Job Location 619 Euclid Avenue
address

Description of Use Addition to Home

RESIDENTIAL PLAN CORRECTION SHEET

ADDENDUM to Permit No. 793-77
 Owner M. LOMBARDI
 Location 619 EUCLID AVE.

Plan Approval
By RA Date 8-2-77

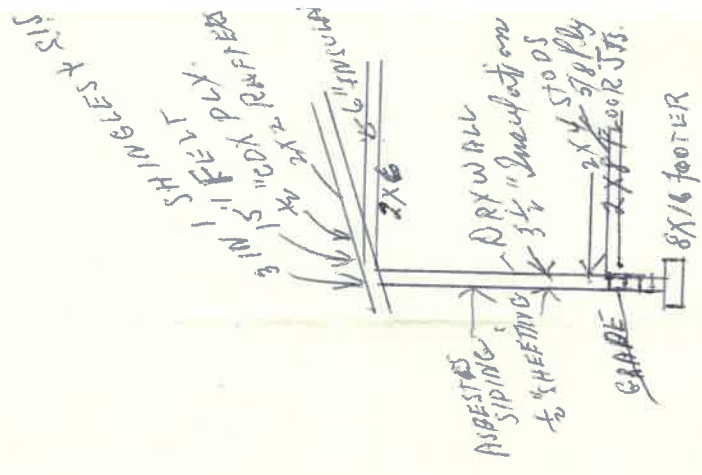
<input type="checkbox"/>	Min. size of footer....." x"
<input checked="" type="checkbox"/>	Provide anchor bolts 1/2" @ 8" o.c. 1' from each corner. Embedded 8" concrete and 15" in masonry.
<input type="checkbox"/>	Show size of basement columns.
FRAMING:	
<input type="checkbox"/>	Show size of wood girder in.....
<input type="checkbox"/>	Provide design data for structural member in.....
<input type="checkbox"/>	Floor joists under sized in.....
<input type="checkbox"/>	Provide double joists under parallel partitions.
<input checked="" type="checkbox"/>	Provide 1" x 4" let in corner bracing or approved sheathing.
<input type="checkbox"/>	Show size of headers for openings over 4' wide.
	Show size of members supporting porch roof.
<input checked="" type="checkbox"/>	Provide double top plate.
<input type="checkbox"/>	Provide design data for pre-fab. wood truss/members.
<input type="checkbox"/>	Ceiling joists undersized in.....

ADDITIONAL CORRECTIONS: WOOD JOISTS CLOSER THAN 18" TO EXPOSED EARTH SHALL BE APPROVED FOR SUCH USE. ALSO PROVIDE MIN. OF ONE 9'X20' PARKING SPACE BEHIND BUILDING LINE.
